JOINT REGIONAL PLANNING PANEL (Sydney East Region)

JRPP NUMBER:	2012 SYE 105
DA NUMBER:	LDA2012/0417
LOCAL GOVERNMENT AREA:	City of Ryde
PROPOSED DEVELOPMENT:	<p>Demolition of an existing building and the construction and use of a 7 storey mixed use development with ground floor retail, 62 residential units (12 studios, 37 x 1 bed and 13 x 2 bed) and parking for 82 vehicles within 3 basement levels.</p> <p>The application includes development on both private land and public land (road reserve), the latter being owned by the City of Ryde Council.</p>
STREET ADDRESS:	<p>1-3 Wharf Road Gladesville, plus areas of existing public roads in Meriton Street and Wharf Road.</p> <p>The total “site” area is 1,330m², comprised of 1-3 Wharf Road (625m² approx.) and road reserve (705m²).</p>
APPLICANT:	Windesea Build Pty Ltd
NUMBER OF SUBMISSIONS:	52 objections and 132 letters of support. The vast majority of these letters of objection and support were in a pro-forma format.

RECOMMENDATION	Submission of amended plans for further consideration by the Panel.
REPORT BY:	SJB Planning, consultant town planners to City of Ryde Council.

Assessment Report and Recommendation

Figure 14: Location of 22m height standard shown as dotted red line

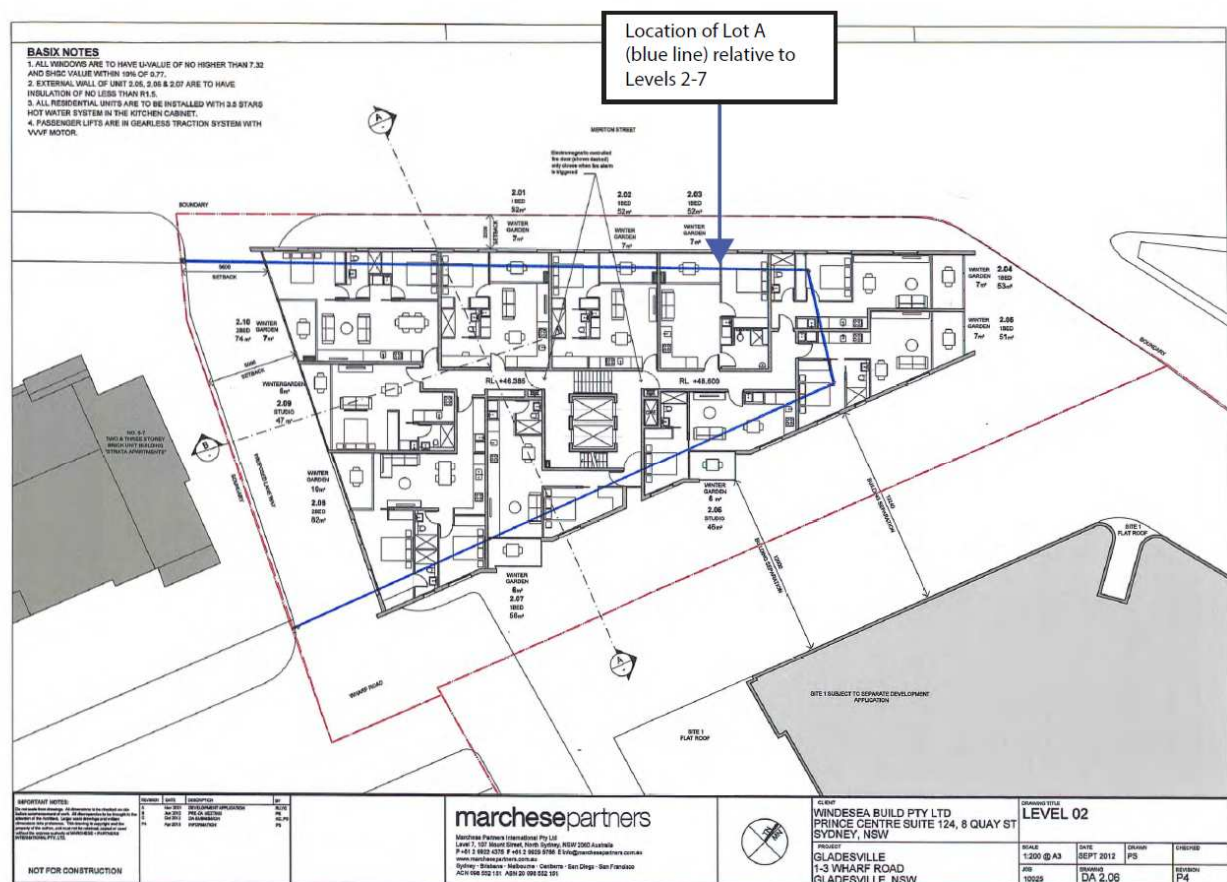
Images provided by the architect showing the areas of compliance and non-compliance are included below. The 22m maximum height is shown as a red dotted line across the top of the building:

At the rear of the site the building not only exceeds the height standard, it is also a storey greater than the RDCP 2010 and extends beyond the 8m setback contained in the RDCP 2010. Due to this additional building bulk and scale at the rear, it is recommended that the top level be setback from the rear to at least meet the RDCP 2010 setback control, consistent with the UDRP comments.

Comment: Amendments have been made to increase the floor-to-floor height to 2.975m which is acceptable. The rear of the building exceeds the 22m height standard, the 7 storey RDCP 2010 control and encroaches into the RDCP 2010 setback control of 8m. As discussed above, due to the additional overshadowing to No 5 Wharf Road (additional to a complying development) the top level at the rear of the development should be amended to achieve as a minimum the 8m rear setback and maximum 6 storeys.

Figure 16: RDCP 2010 Key Sites built form plan

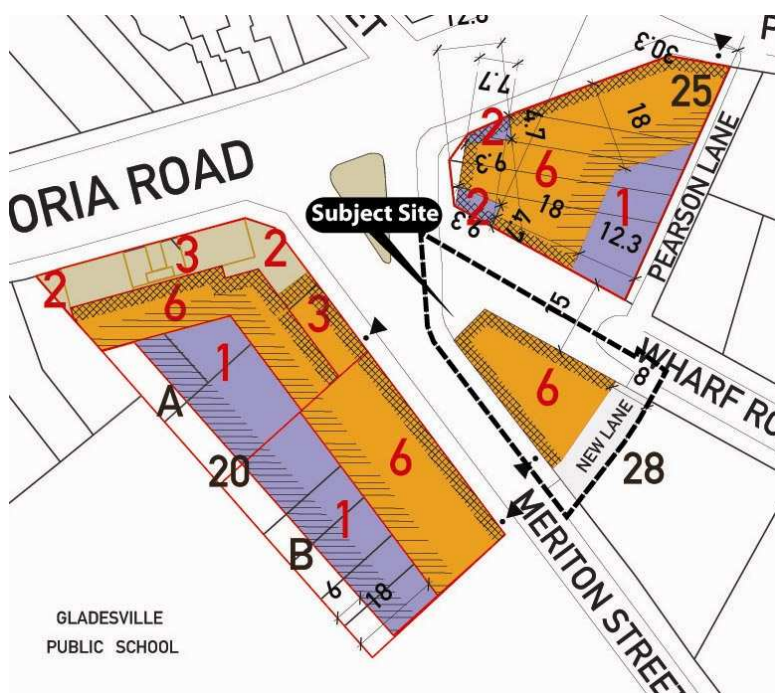
As noted in the report the DA is inconsistent with the key sites diagram for the subject site. The Key Sites diagram is shown below in Figure 16.

The DA does not comply with the Key Sites diagram contained in RDCP 2010.

Figure 18: ground floor of the development relative to Lot A, shown in blue

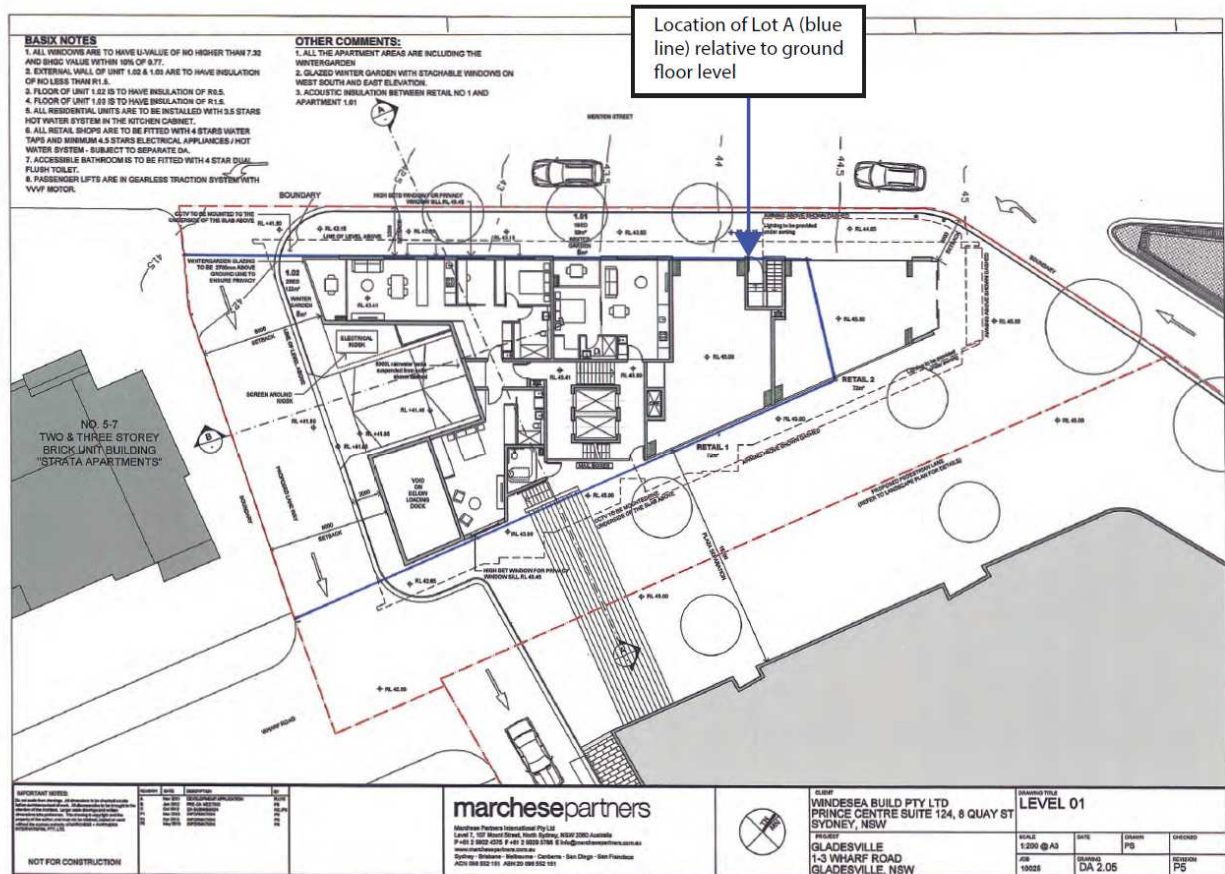
The departure from the Key Sites diagram and related controls is the threshold issue associated with the DA. Due to the Council and the applicant agreeing, separately to the DA process, to respectively sell and purchase additional land and establish a larger development site, the opportunity exists for the applicant to pursue a greater scale and density of development, based on the enlarged development site.
